Groundwater Application Review Summary Form

Application # G- __18889__

GW Reviewer __Aurora C Bouchier__ **Date Review Completed:** __January 15, 2021__

SUBJECT: Application G- 18889   Supersedes review of May 13, 2020

Geologic Map

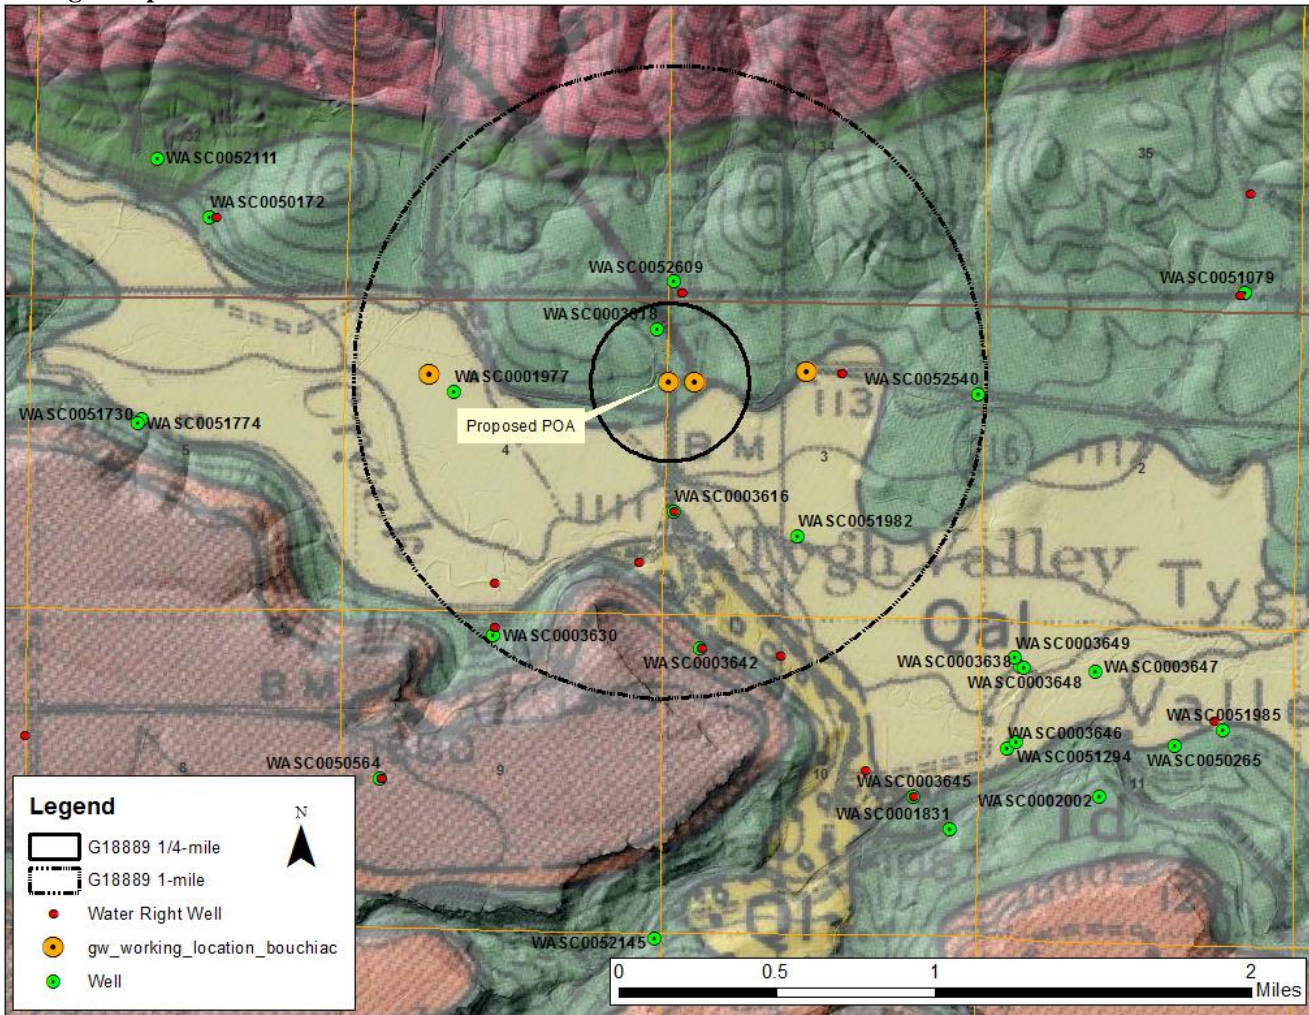
A4.   **Comments:** *The application states the source aquifer as the Tygh Valley Formation. However, at the proposed location it appears likely that the well would actually be constructed into water-bearing zones within the Dalles Formation (Waters, 1968). The application states that the well inspector will be consulted on all aspects of well completion.

Basis for aquifer confinement evaluation: *Based on the location it appears that the well will be constructed into interbedded sandstones/claystones and lava flows of the Dalles Formation. The nearby well logs list the SWL above the first water-bearing zone, but not by a large amount. It may be more accurate to describe the aquifer as semiconfined.

Water-Level Trends in Nearby Wells

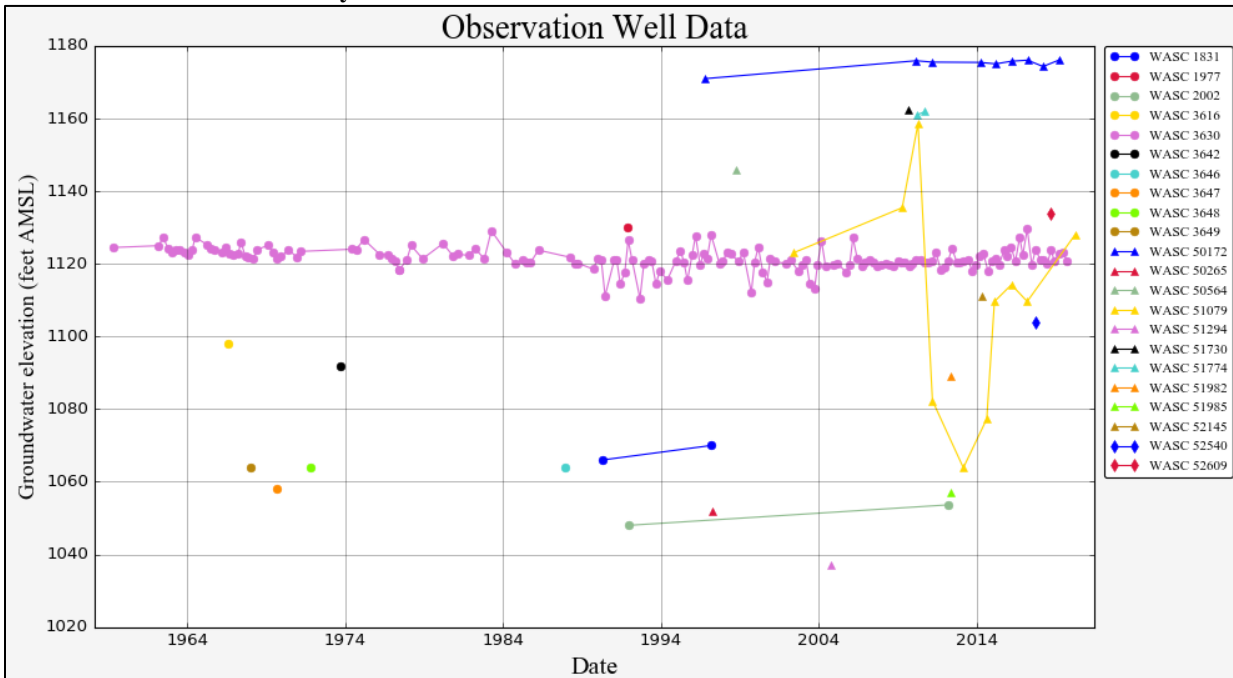
B3.   **Groundwater availability remarks:** _____
There are a number of nearby wells completed in the Dalles Formation. WASC 3630 (located on the south edge of Tygh Valley) has been monitored since the 1960's and shows no decline and a water-level coincident with nearby reaches of Tygh Creek. Two nearby wells (WASC 51079, located to the west along the north flank of Tygh Valley and WASC 51079 located on the hillsides to the northeast) have water-level permit conditions. Water-level measurements from WASC 51079 are relatively erratic, likely a response to pumping and restricted to a small locality. Aside from WASC 51079, the hydrograph for nearby wells indicates overall stable conditions at the current use.
